P.O.A.D.P.
FOR
REDWOOD BUSINESS PARK

Re: Redwood Business Park

POADP # 620

P.O.A.D.P REVIEW

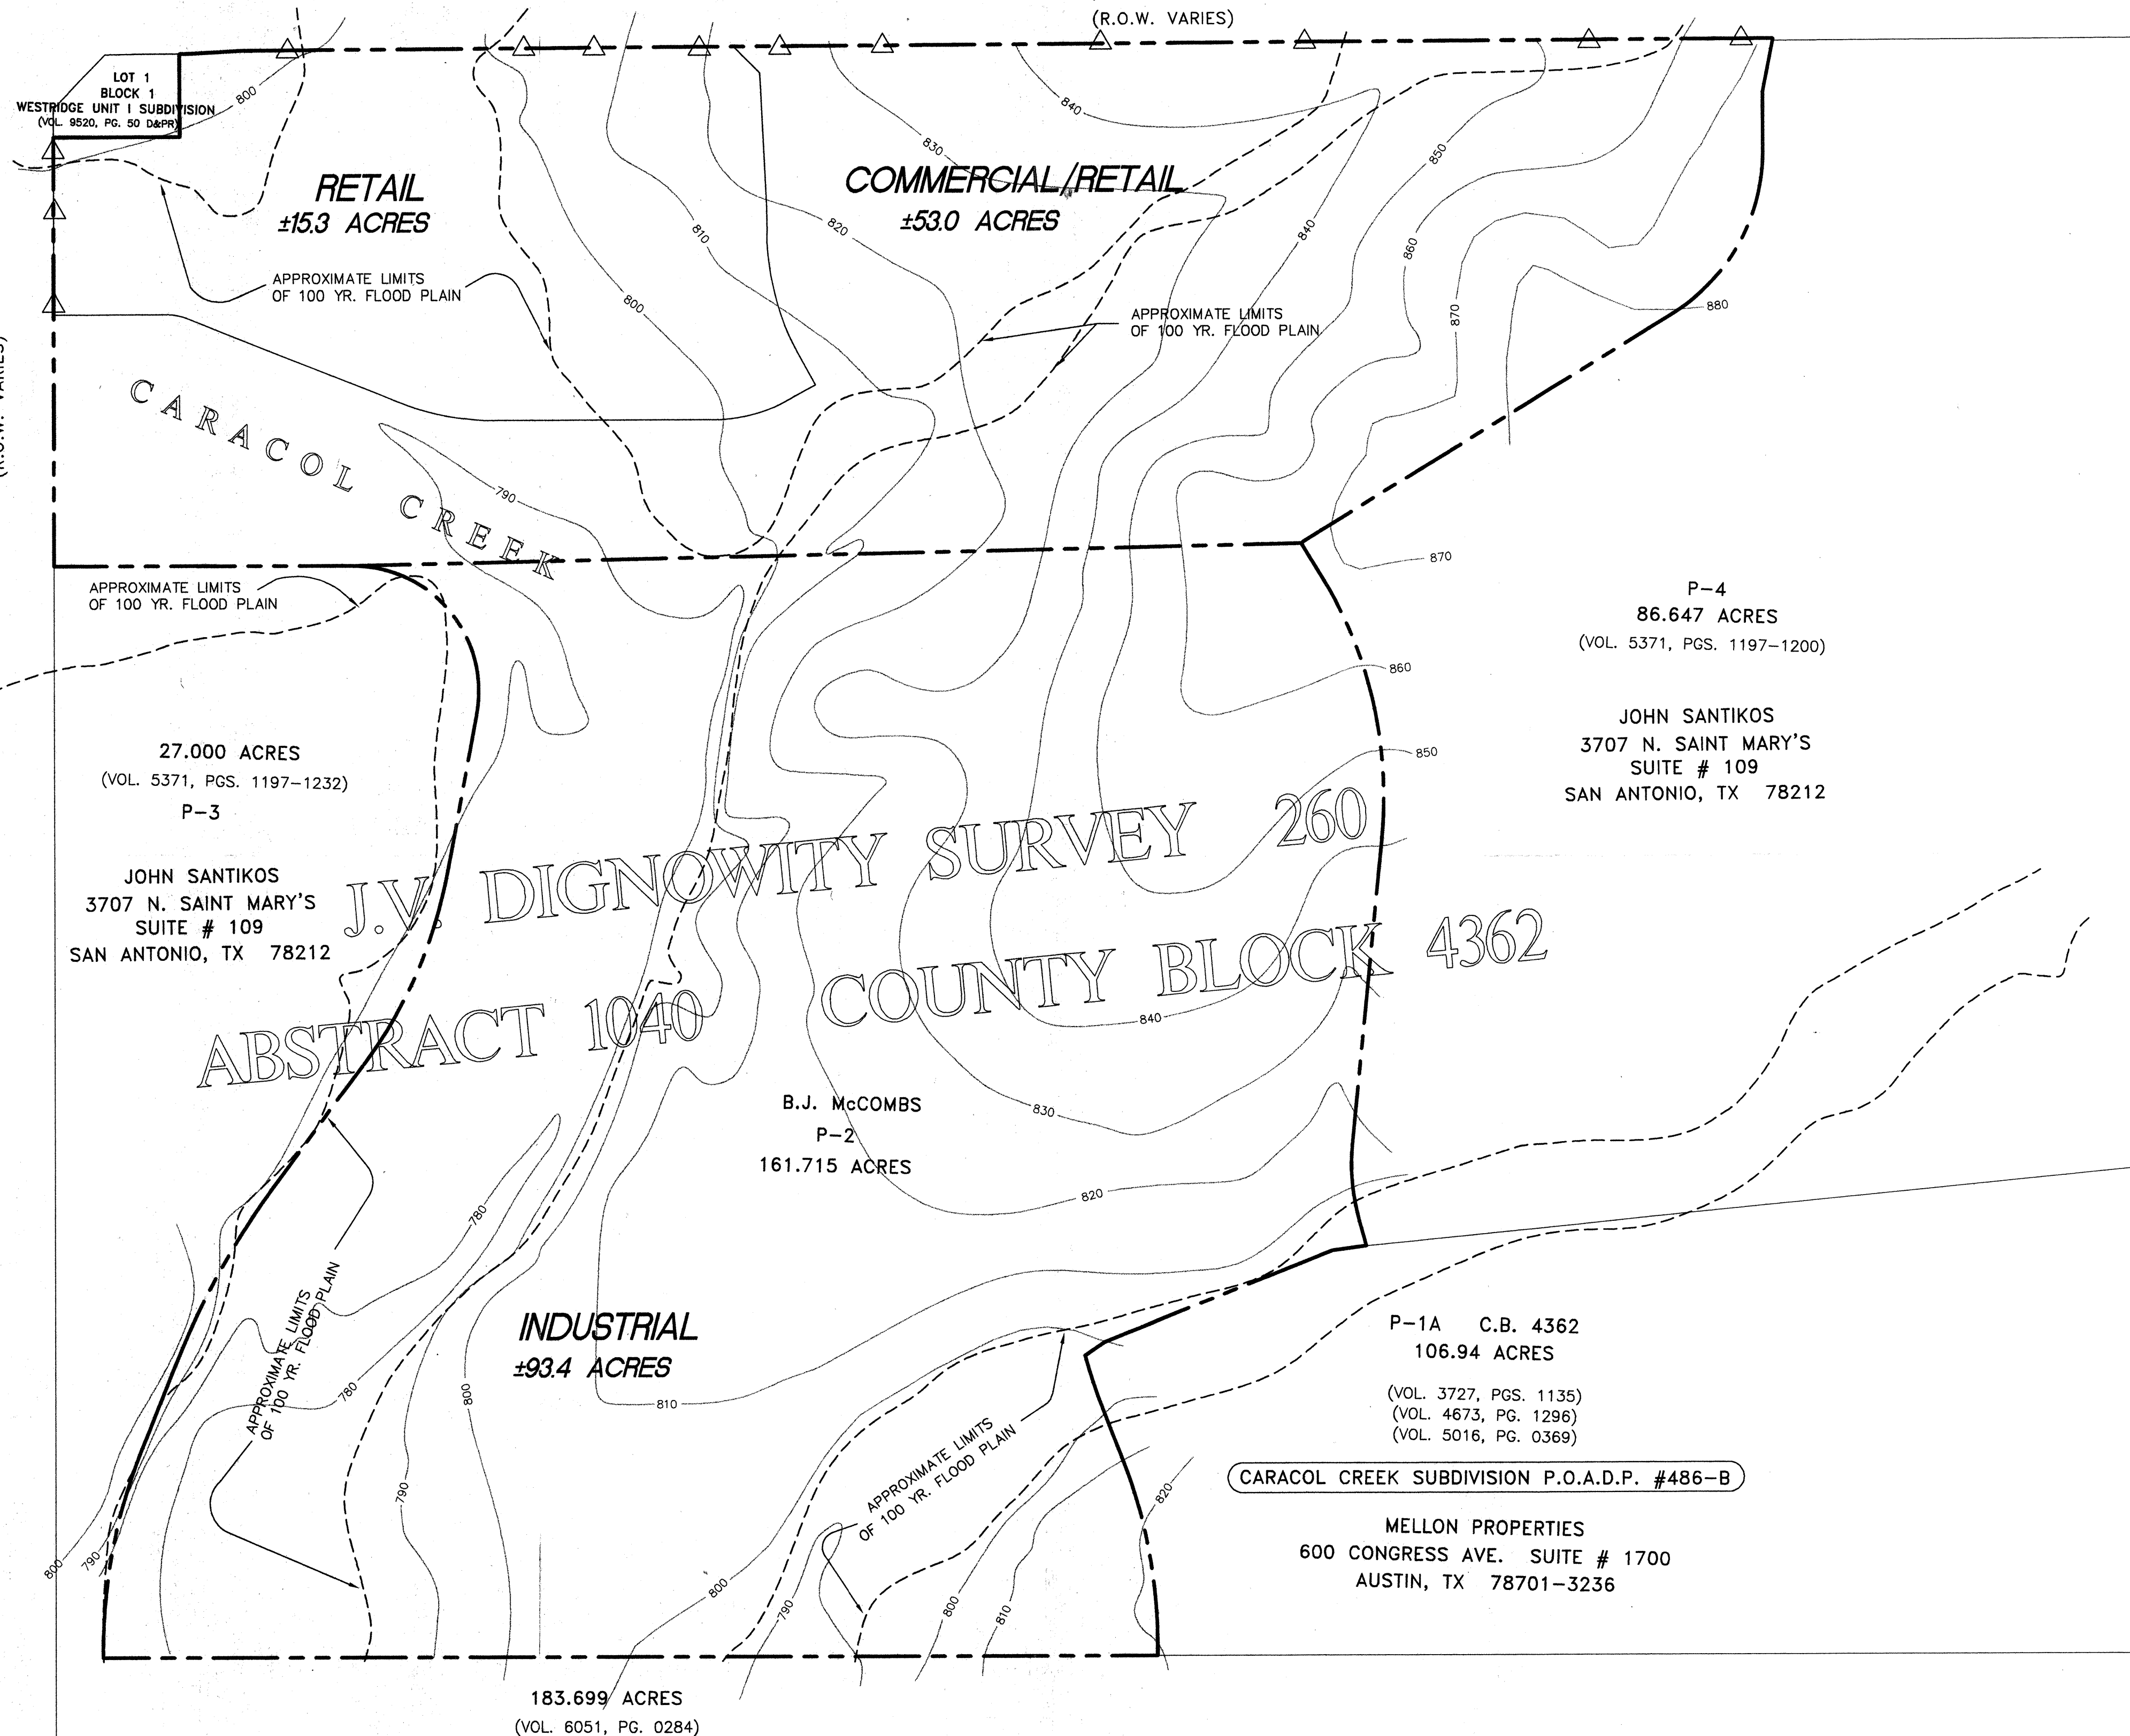
TIA ~~was~~ ~~not~~ ~~done~~
Show the location of seaseape
with respect to this development.

- flood plain I.D. adjacent POAPP
- Show Park place Job
- Show Scenescape
- TIA
- trees
- ~~Driveway location are~~
subject to TIA &
~~TXDOT appra~~

→ Show Seeseepe
as an extension from
Park place as noted
- call Bob

- no residential frontage
on a collector.

REVISIONS:
10/13/98 - ADDED
"SEASCAPE" AND
NOTE #5.

COMMENTS Elizabeth, The road called "Seascape" is not within or does not abut this POADP and is no longer an issue with the Public Works Department. The Traffic Department is still in the process of reviewing the massive TIA for this job. Other revisions have been made based on your comments. Please call if you have any questions. Thanks!

LOOP 1604

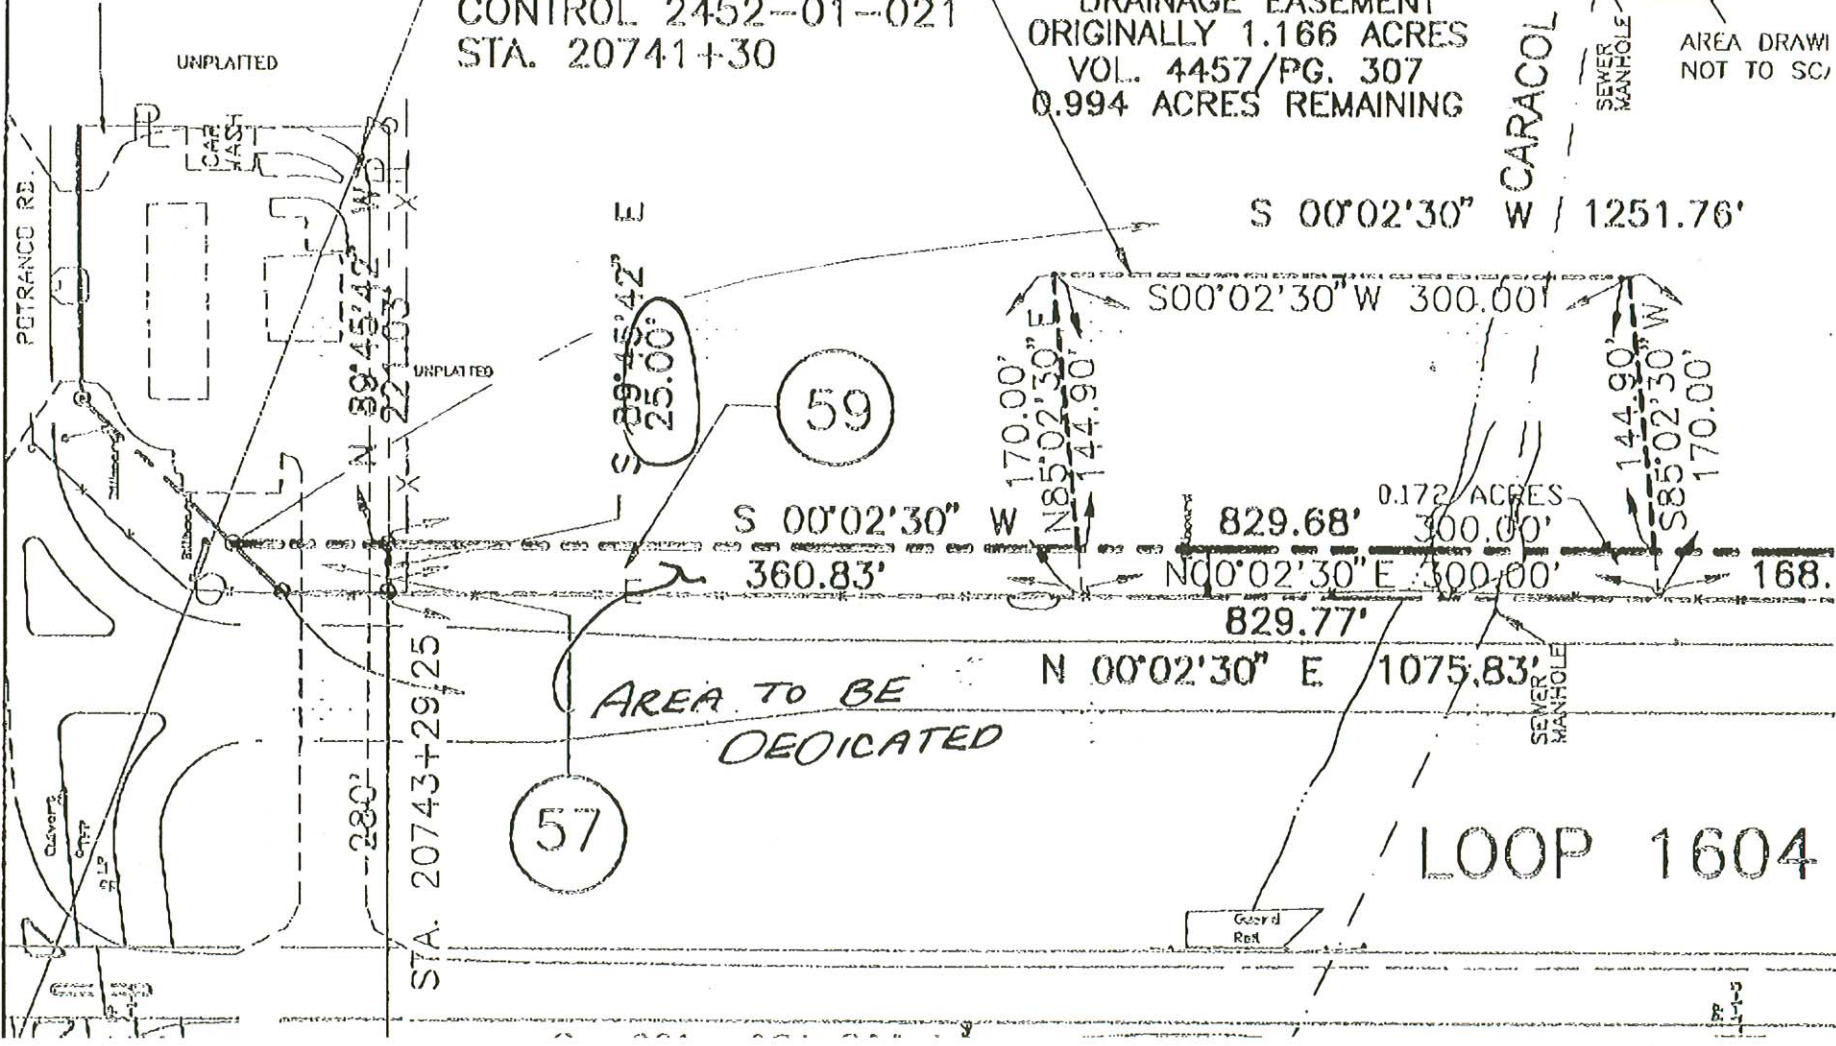
A dedication of 25' will be required, see the attached copy of the TxDOT ROW map.

A dedication of 25' will be required, see the attached copy of the TxDOT ROW map.
